RemarksIn the Drawings37 CFR 1.83(a) Objections

The Examiner objected to the drawings pursuant to 37 CFR 1.83(a) for the reason that they fail to show certain features. Specifically, the Examiner objected because:

Fig. 10

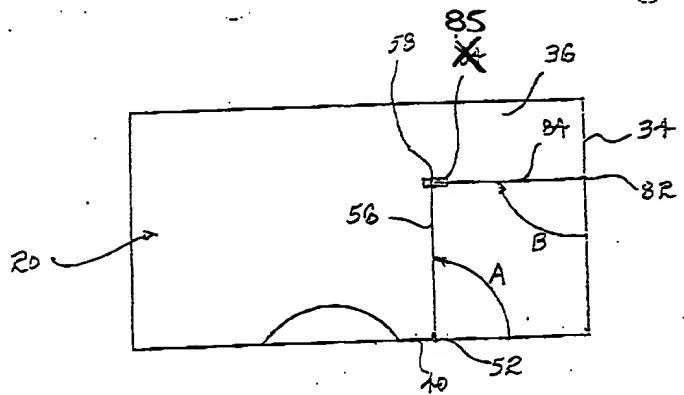
(1) *Front wall latch means 85* was not shown. Front wall latch means 85 is shown on Figure 10. It was mislabeled as "84". A correction has been made.

Fig. 11

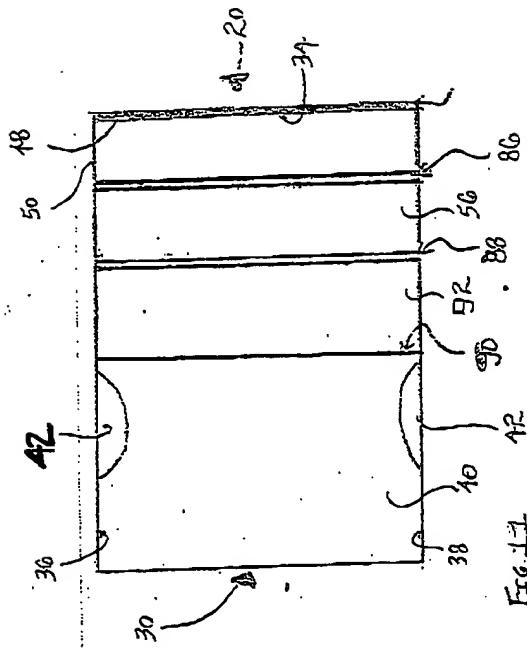
In Figure 11, the objected to lead line has been amended to illustrate reference 42.

FIG. 15

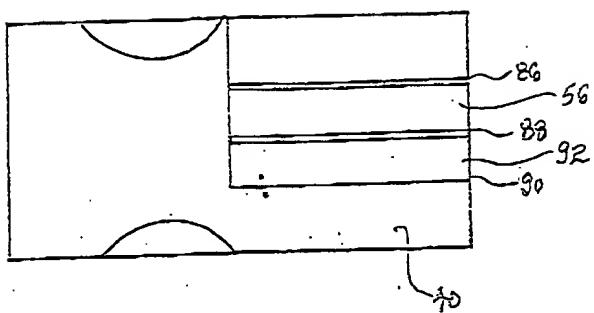
In reference to the objection to Figures 14 and 15, the Specification has been amended to better describe the invention in relation to the drawings.

The Examiner objected to the drawings pursuant to 37 CFR 1.83(a) for failing to show every feature of the claimed invention. Applicant submits that the two living hinges as claimed in claims 14, 29, 30, and 53 are illustrated in Figures 15 and 16. The living hinges enable the divider to fold in two places to create a compartment.
